# SUMMARY OF EVALUATION FOR TYPE BU-J PACKAGE ON IAEA SS-6 1985 EDITION (AS AMENDED 1990) (1/16)

FEB 17 1994

Subject: Response to Letter Dated February 17, 1994

**BU-7 TEST CONFIGURATION**

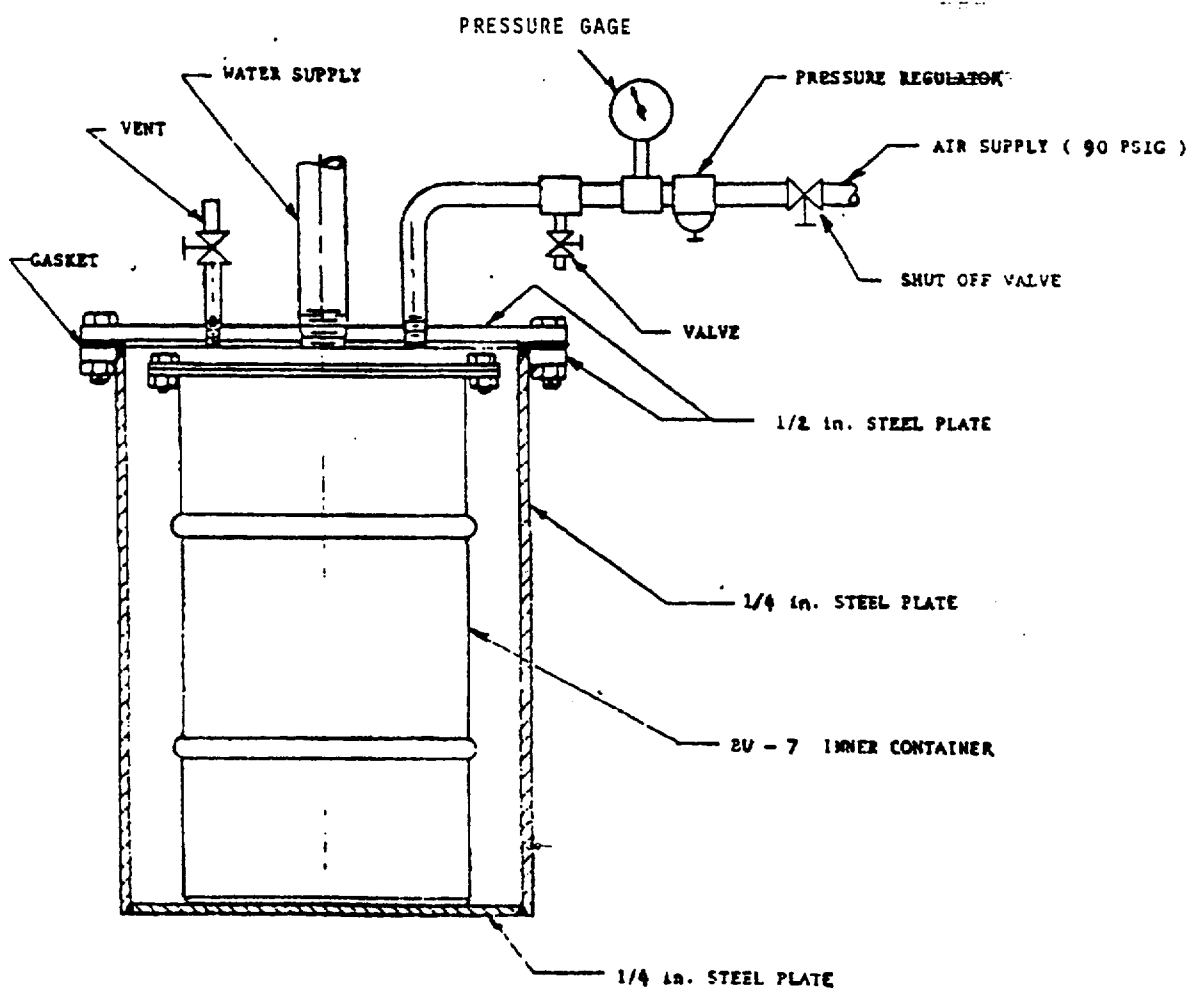
3. The application (supplements dated December 14 and 22, 1993) discusses hydrostatic tests that were performed on BU-7 and BU-J packages. The application is not clear with respect to the details of the tests. Revise the application to clearly address the following:
  - (a) Provide details of the hydrostatic tests performed on the BU-7 package. Include the package configuration, test setup, and package closure method.
  - (b) State whether the packages were newly fabricated or were packages which had been in service. Justify that the tests are representative of packages which are at the end of their service life.
  - (c) State how many specimens of each package type (BU-7 and BU-J) were tested. Note that Appendix B of the application dated December 3, 1993, states that only one BU-7 specimen was tested.
  - (d) Describe how the pass/fail demonstration was made.

Figure I attached defines the test set-up showing air supply valves, pressure gauge, water supply location, vent, configuration, etc. The package component tested in each case was a newly constructed 18-gauge inner container fitted with the specified 3/16" thick, 1-1/2" wide steel flange. Closure of the 3/16" thick steel lid was accomplished using a gasket and twelve 5/16-18 carbon steel bolts as specified for the package. The tests were performed on 18-gauge inner containers at a minimum pressure of 21.4 psig for 8 hours. In passing the test, there was no visual water in-leakage.

**FIGURE IV**

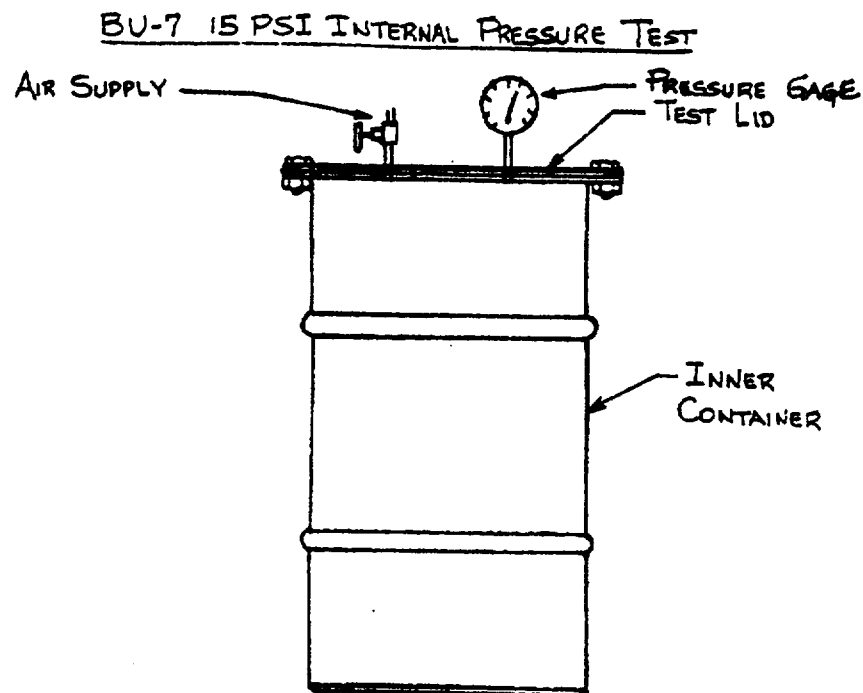
Specify the steps that will be taken for each shipment to verify that the product pails and inner container have been properly closed. Include a leak test to demonstrate that each inner container, as assembled for shipment, is water-tight. Specify the test method, the maximum acceptable leak rate, and the sensitivity of the leak test.

The method used to leak test the inner containers prior to first use is described in Section 5.2.1 of the Consolidated Application. This test involves submerging in water the inner container under 15 psig internal pressure for at least one minute. During this time the container is observed for visible bubbles to determine whether any leaks exist. A sketch of the test set-up is attached (Figure IV).

**PRODUCT PAIL CLOSURE DEVICE**

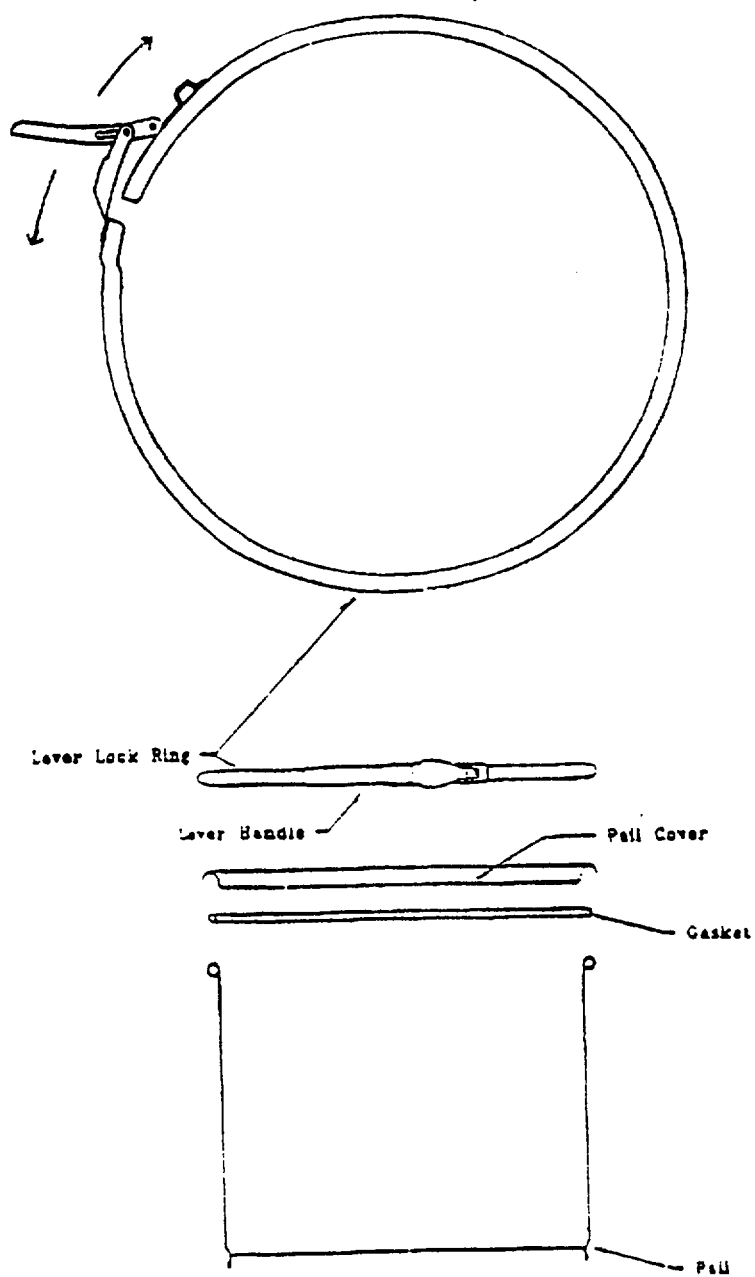
**Provide drawings of the 3- and 5-gallon pails. Include the following information on the drawing: dimensions, tolerances, material specifications, applicable codes and standards for fabricating and acceptance testing the pails, and details of the pail closure.**

codes and standards are contained in the above referenced ANSI standard and DOT regulation. The 24-gauge gasketed pail cover is held in place by a lever locking ring (see Figure V attached).

FIGURE 10A SUBMITTED 3/18/94

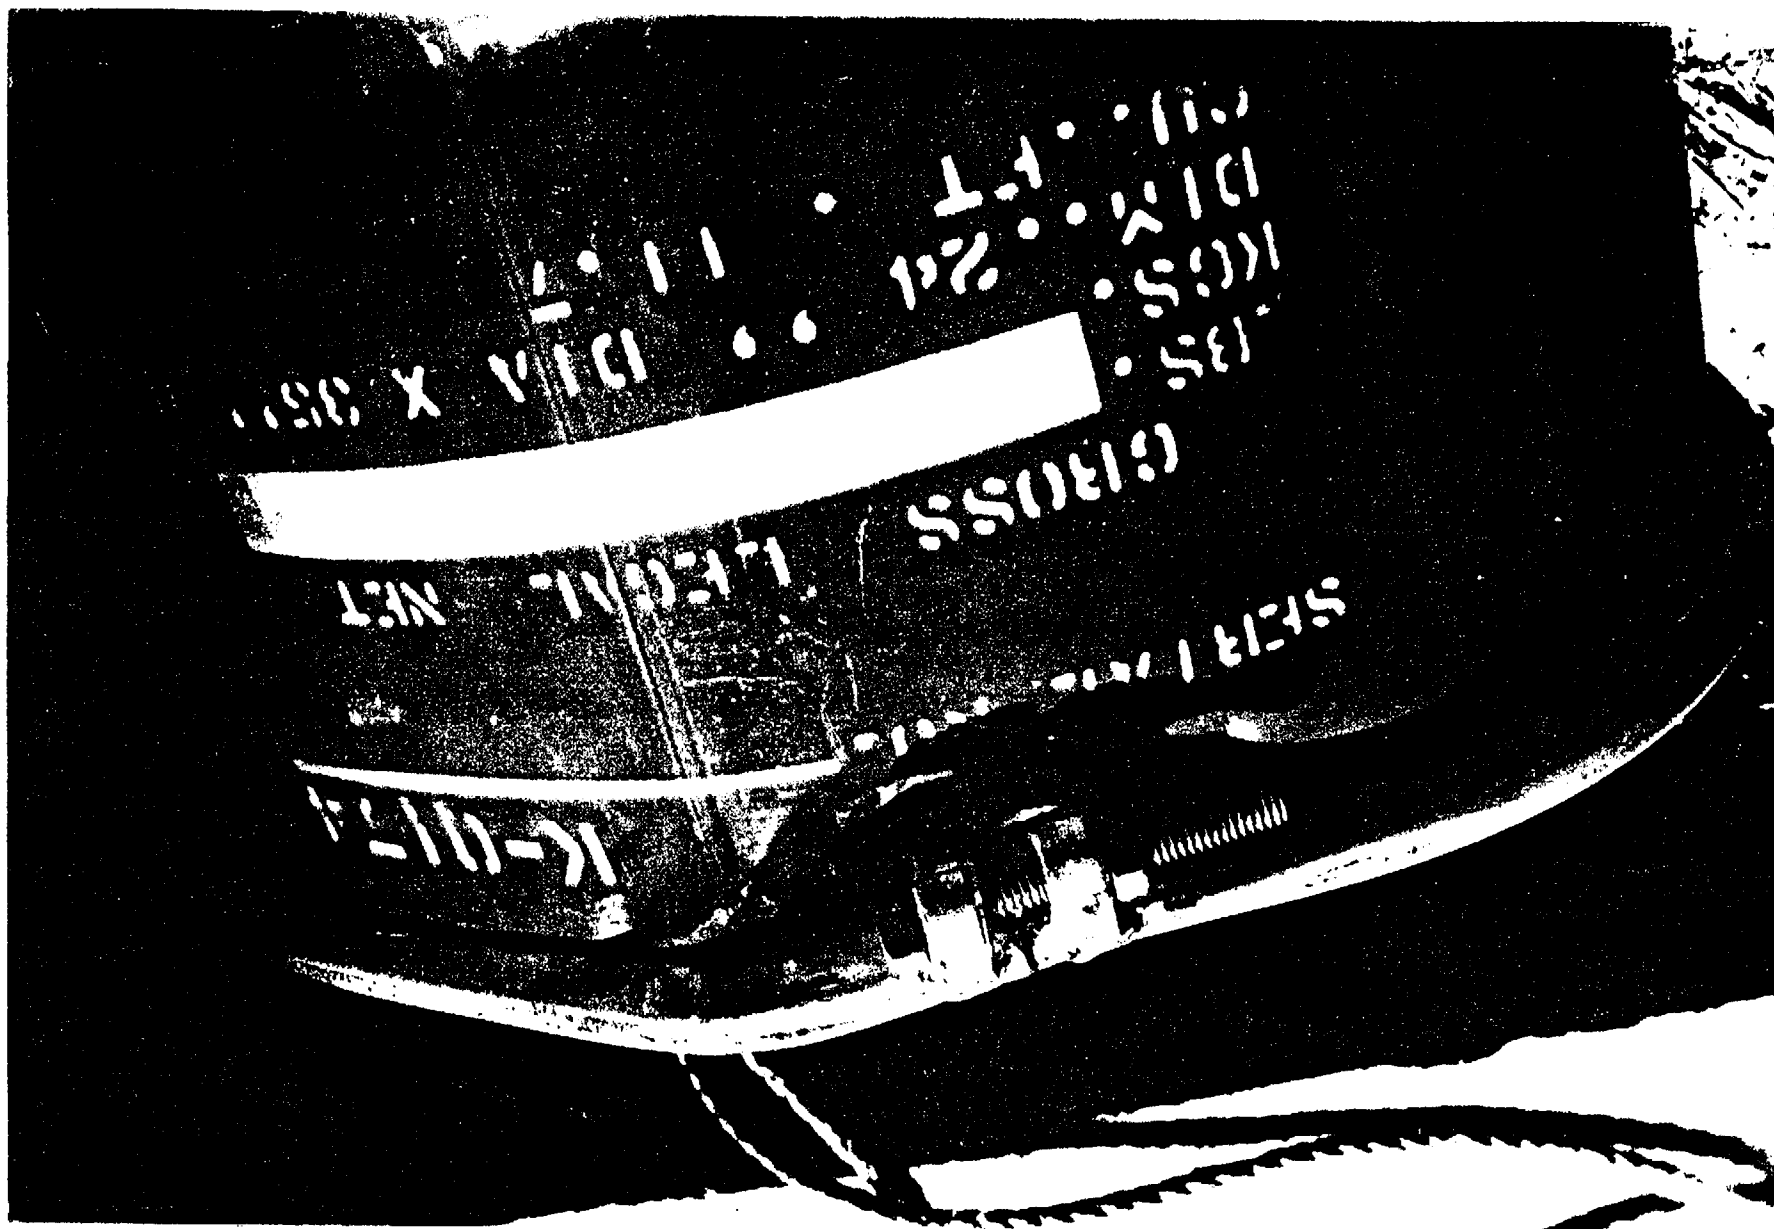
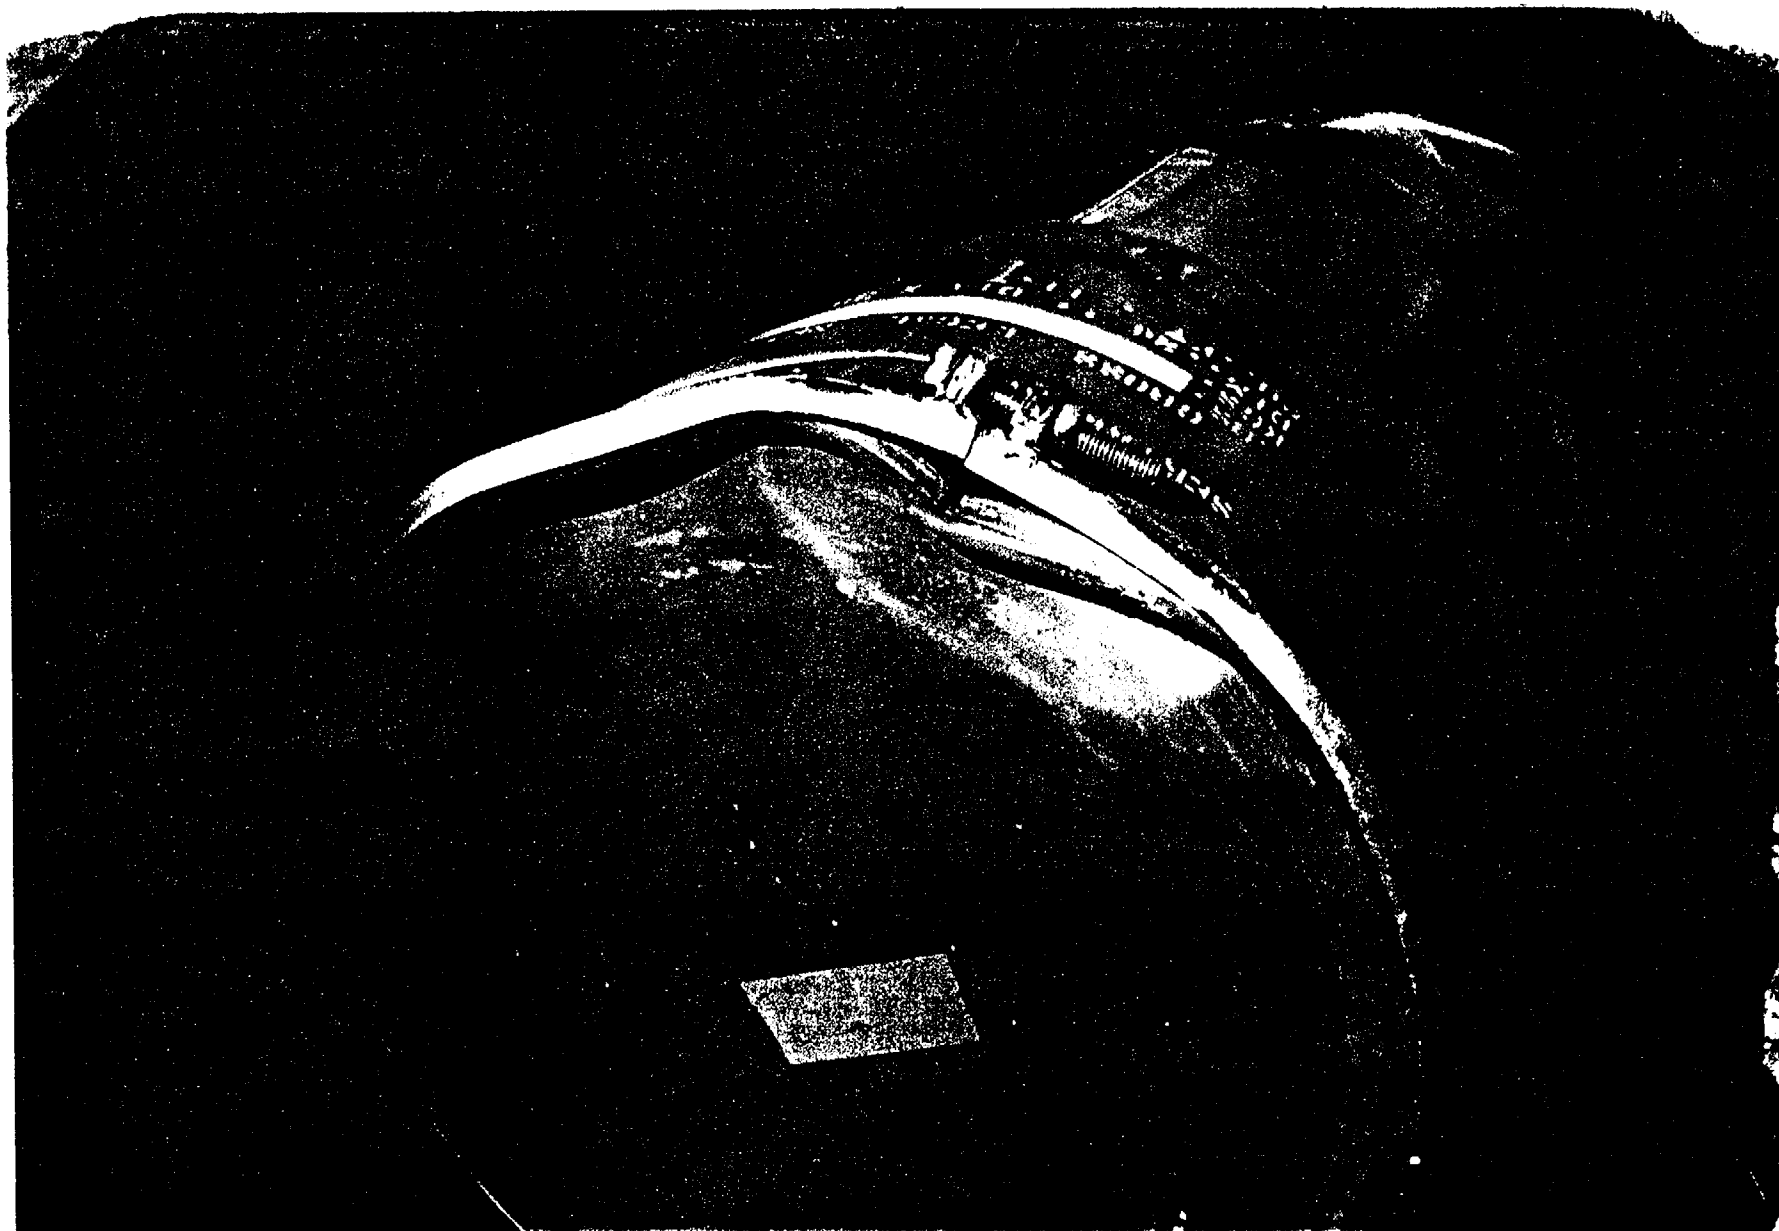
4. Figure No. 10 in Appendix B of the application is incorrectly labelled. It does not appear that this is a photograph of drum No. K-1878 (see, for example, Figure No. 11 in the same appendix). In Figure No. 10, the bolt which secures the drum locking ring appears to be broken. Provide a description of the damage sustained by this bolt. If possible, provide an additional photograph which clearly shows that the bolt did not break due to the 30-foot drop test.

GE has reviewed the report and it appears that Figure 10 is incorrectly labeled. Figure 10 more closely represents the damage done to the top of K-0174 (see Figure 18) and the report has been modified accordingly. Figures 11, 12, 13, and 14 allow easy identification as K-1878.

Figure 10 shows no breakage or damage to the closure bolt and the test engineer interviewed recalls none. The darkened area in question is a shadow as can be seen from the lighting in the photograph (cf the point of the closure ring at the nut location). In support of this position, GE has located two additional photographs from the photo sequence of the bolt on container K-0174 which more clearly show from two different perspectives that the bolt is not damaged. The photographs are enclosed and are being incorporated into the test report (Figures 10A and 10B) to avoid the ambiguity generated by Figure 10.

2. Figures 10A and 10B have been added. These are photos of BU-7 serial number K-0174 that have not been provided to the NRC in the past. They show that the bolt securing the outer ring was not broken. These two new figures are also identified with the drum serial number and the date of this transmittal.
